Access Compliance Report

Public Rights-of-Way

(Curb Ramps)

Intersection ID: 42551	Main Street: ENEIDA_SUE_DR	Cross Street: HANNAH_RAE_CT	Location: NE
ADA ID: 52C2CCC898A9	Ramp Type: PerpDiag	Initial Pass/Fail: Fail	Overall Compliance: No
Severity Score: 10			
Codes/Mitigation Info/Possible Solution		Field Measurements/Component Compliance

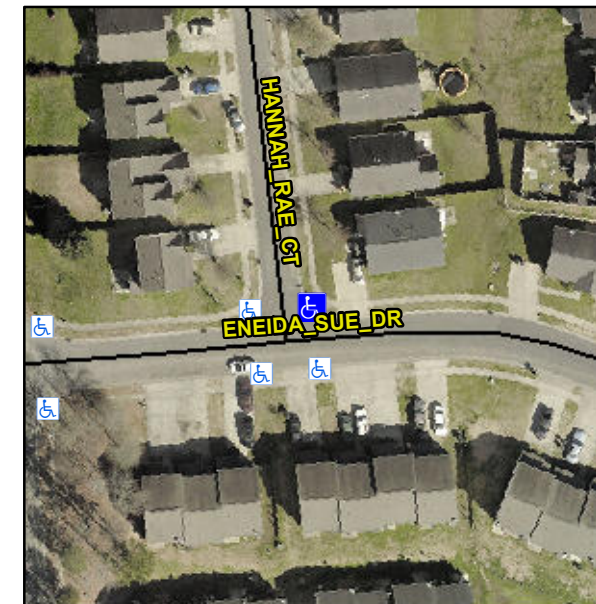
Not Found, R304.5.1, R304.5.3

Compliance	Description	Data	Compliance	Description	Data
N/A	Ramp Length (in)	49.0	Yes	Ramp Slope (%)	6.9
No	Ramp Width (in)	39.0	No	Ramp XSlope (%)	4.6
N/A	Flare Type LT	N/A	N/A	Flare Type RT	N/A
N/A	Flare Slope LT (%)	N/A	N/A	Flare Slope RT (%)	N/A
N/A	Flare Traversable LT?	N/A	N/A	Flare Traversable RT?	N/A
N/A	Landing Length (in)	N/A	N/A	DWS Provided?	N/A
N/A	Landing Width (in)	N/A	N/A	DWS Contrast?	N/A
N/A	Landing Slope (%)	N/A	N/A	DWS Length (in)	N/A
N/A	Landing X Slope (%)	N/A	N/A	DWS Full Width?	N/A
N/A	Landing Curb? (Y/N)	N/A	N/A	DWS Offset (in)	N/A
N/A	Shared Landing?	N/A			
N/A	Gutter Ponding?	N/A	N/A	Gutter Slope (%)	N/A
N/A	Gutter Lip Ht (in)	N/A	N/A	Gutter X Slope (%)	N/A
N/A	Painted X Walk1?	No	N/A	Painted X Walk2?	No
	X Walk 1 Direction	To W		X Walk 2 Direction	To S
N/A	X Walk 1 Width (in)	N/A	N/A	X Walk 2 Width (in)	N/A
	X Walk 1 Slope (%)	7.2		X Walk 2 Slope (%)	0.3
	X Walk 1 X Slope (%)	1.1		X Walk 2 X Slope (%)	6.6

N/A	Ramp inside XWalk1?	N/A	N/A	Ramp inside XWalk2?	N/A
	Road Slope (%)	4.3	N/A	Clear Space?	N/A
	Road X Slope (%)	8.0	N/A	Clear Space to XWalk (in)	N/A
N/A	Any Obstructions?	N/A	N/A	Storm Grate/Utility Hazard?	N/A
	Obstruction Type			Storm Grate/Utility Type	
		N/A			N/A
			Yes	Surface Condition? (G/P)	Good

Remove & Replace Curb Ramp With Two New Directional Ramps or Equivalent.
